ZAYO’S PRINEVILLE TO RENO PROJECT

CPUC MINOR PROJECT REFINEMENT FORM

Date Requested: 27 June 2025	Report No.: 22/RFI 506
Date Approved: 7/28/2025	Approval Agency: CPUC (Caltrans approval pending - RFI 506)
Property Owner(s): Caltrans	Location/Milepost: MP M4 - M7.9
Land Use/Vegetative Cover: Ruderal (maintained highway shoulder near edge of pavement)	Sensitive Resources: Requested changes result in avoidance of cultural resources.

Zayo requests to move the running line closer to edge-of-pavement (EOP) between MP M4 - M7.9 (STA 710+32 TO STA 906+28) to avoid a cultural site.

SHEET NO.: 68 of 75
SCALE: 1"=100'
JOB NUMBER: UPR
DRAWN BY: WP
DATE: 4/8/25

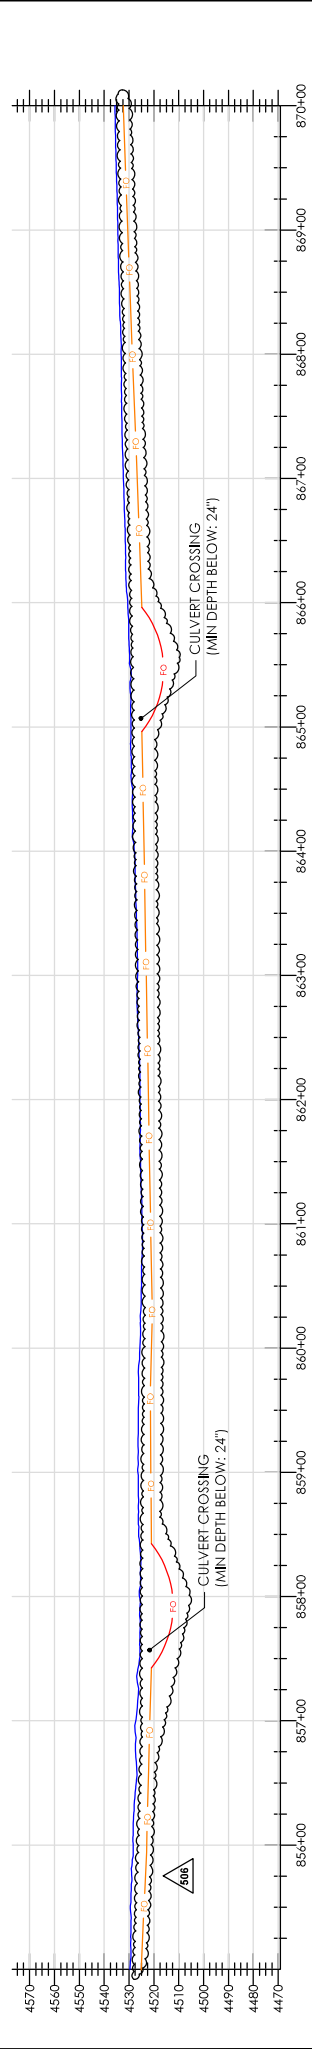
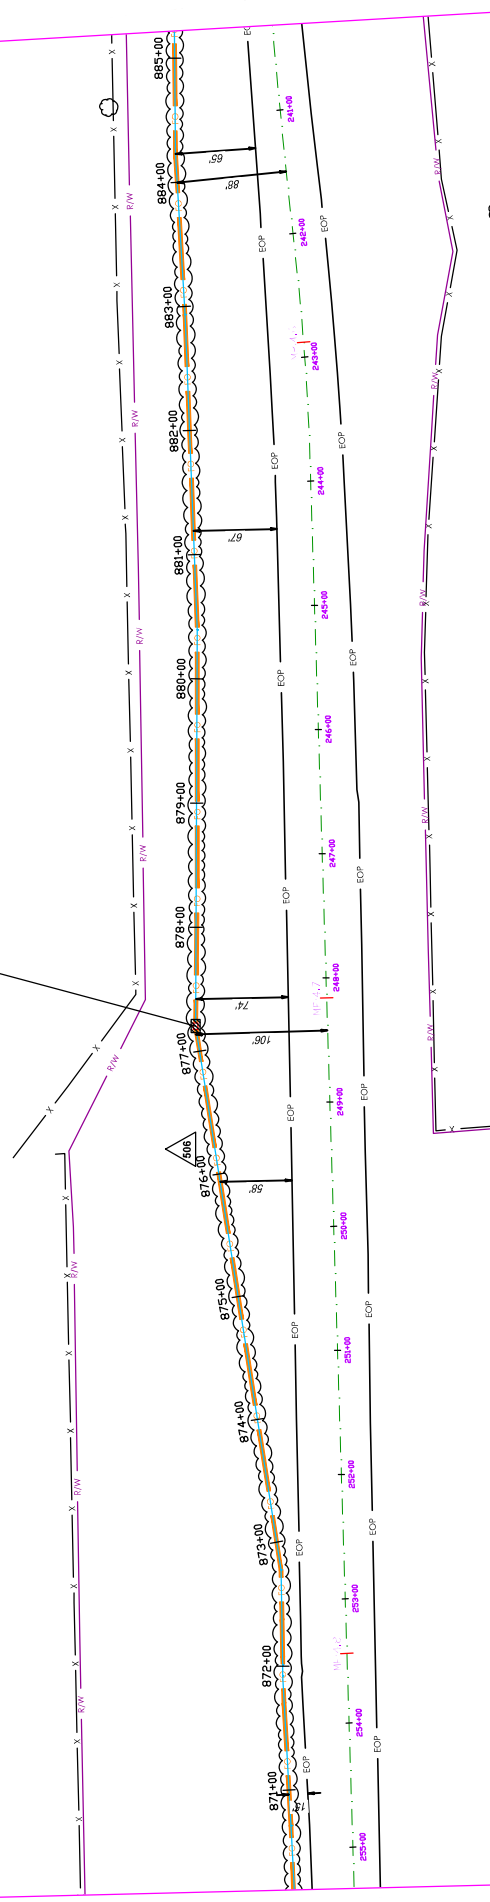
REF NO. 506
SHIFT R/L CLOSER TO EOP
TO AVOID ANY CULTURAL
SITE
STA 710+32 TO STA 906+28

SHEET NO.: 69 of 75
SCALE: 1"=100'
JOB NUMBER: UPR
DRAWN BY: WP
DATE: 4/8/25

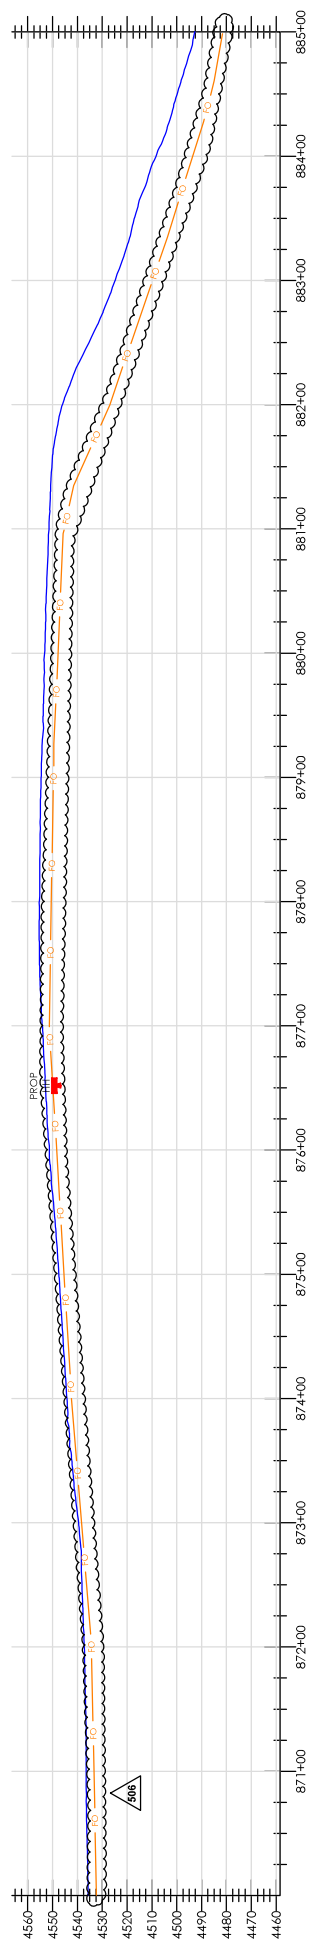
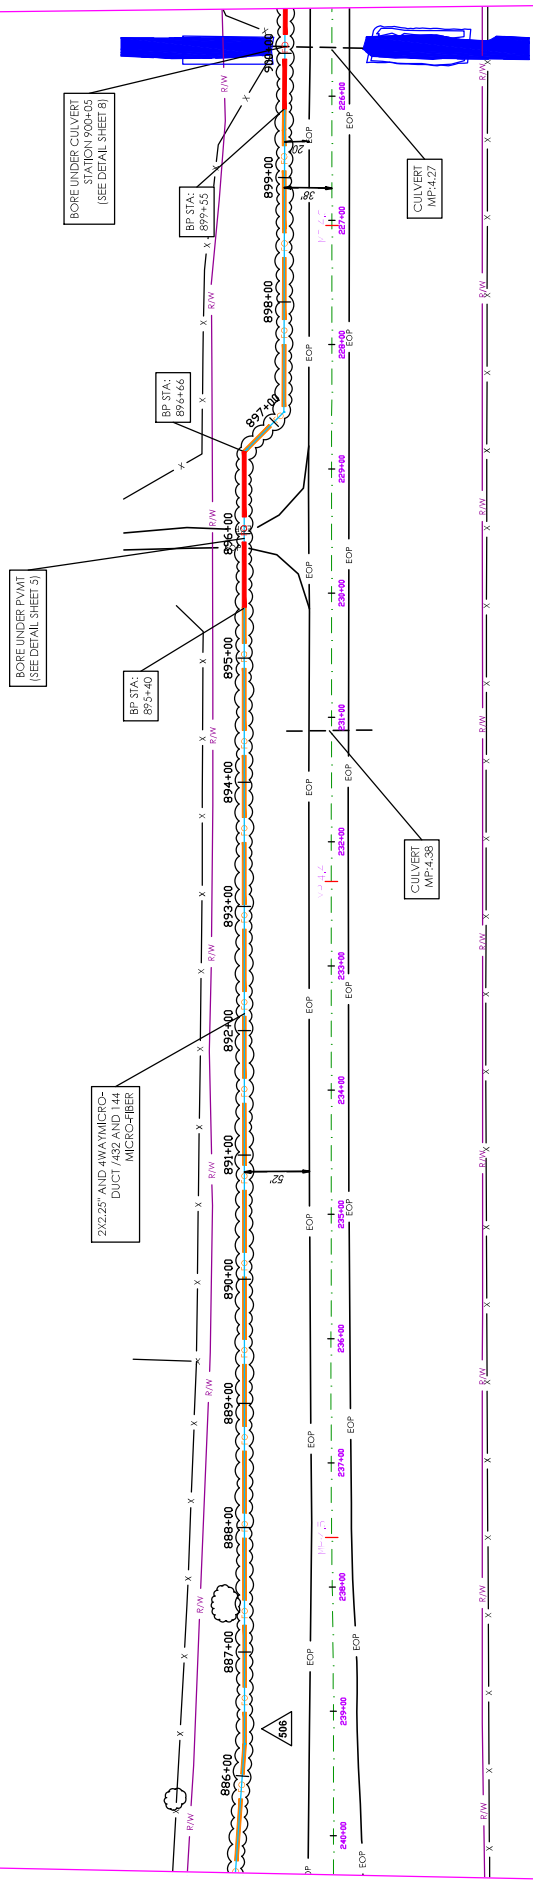
REF. NO. 506
SHIFT R/L CLOSER TO EOP
TO AVOID ANY CULTURAL
SITE
STA 710+32 TO STA 906+28

PLACE (1) 30"x48"x36"
HANDHOLE LEAVE 100' SLACK
HANDHOLE STATION 877+21
(SEE DETAIL SHEET 4)
